**AGENDA
FARRAGUT MUNICIPAL PLANNING COMMISSION**

**May 17, 2018
7:00 p.m. Farragut Town Hall**

**MINUTES
FARRAGUT MUNICIPAL PLANNING COMMISSION**

Drawing No.:
C1.2

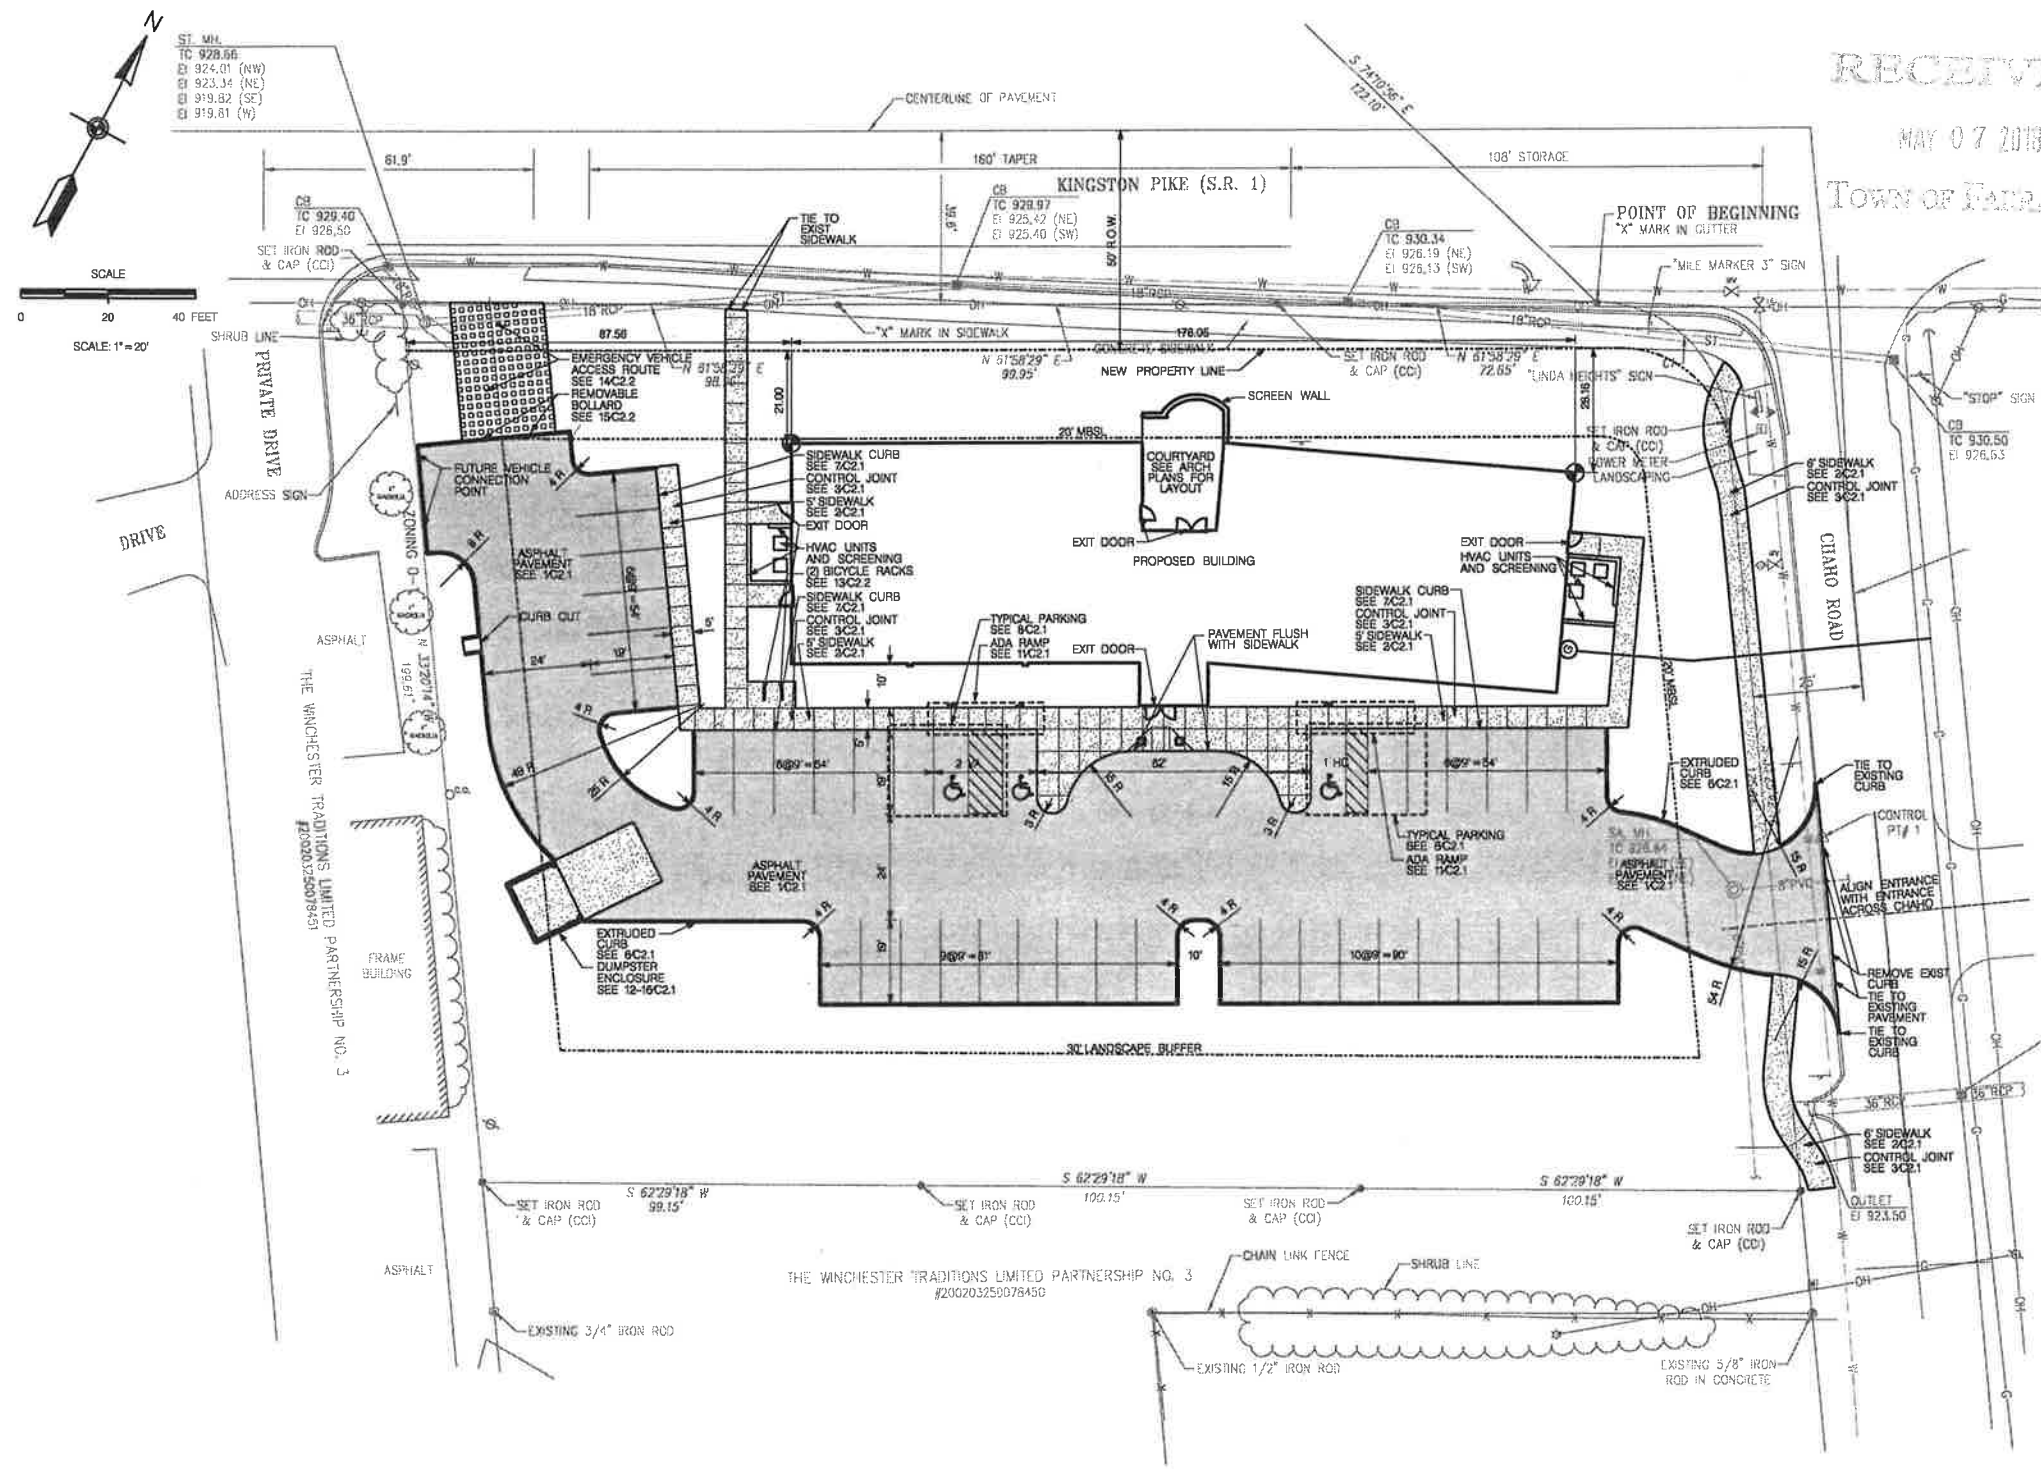
- 8) Please clearly label all building entrances. Please also clarify the structure at the front of the courtyard that extends into setback area. *Building entrances labeled on C1.2. Walls at the front of the courtyard are decorative landscape walls 3'-6" height.*

- 13) Please add a future vehicular connection point to the property to the west. The connection point should be stubbed to the property line and an easement will need to be provided to accommodate cross-lot access in the future. *Connection has been added to C1.2*

- 14) Please clearly identify the location of any transformers on the electrical site plan and remove/modify the note regarding the ground mounted sign. Ground mounted signs, including locations, are reviewed by the Town's VRRB. *HVAC condensers/screen walls have been added to C1.2. Transformer to be located on electrical site plan.*

- 15) Please either add a note stating that there will be no antennas or clearly identify them on the plan. *Note added to C1.2 that no antennas will be located.*

- 16) There is a discrepancy between the building area listed in note #2 and note #9 (parking summary) on the site plan, please correct and clarify. *Building area corrected on C1.2.*

- 18) The developer will be required to extend a sidewalk, with 6-foot grass strips, southward along the sites Chaho Rd. frontage. Please include it on the site plan and ensure that its location does not conflict with the Linda Heights Subdivision sign. *Sidewalk on Chaho road has been added to C1.2*

- 19) Please clearly identify the location of HVAC systems and document screening details. The building must screen the units. *HVAC pads and screening have been added to C1.2*

- 22) As part of the plat, the required right of way must be dedicated. Please ensure that the building placement reflects the setback from the adjusted right of way (70 feet from the centerline of Kingston Pike would be the minimum front setback – the proposed building does not appear to comply with this requirement). *The adjusted right of way of 70 feet from centerline of Kingston Pike to be included as part of the recombination of plats. Revised building location and setback is reflected on C1.2.*

- 25) Plans should indicate new ROW line along Kingston Pike which will result from the resubdivision plat. The building setbacks are from that line. *C1.2 shows additional right of way and change in setback.*
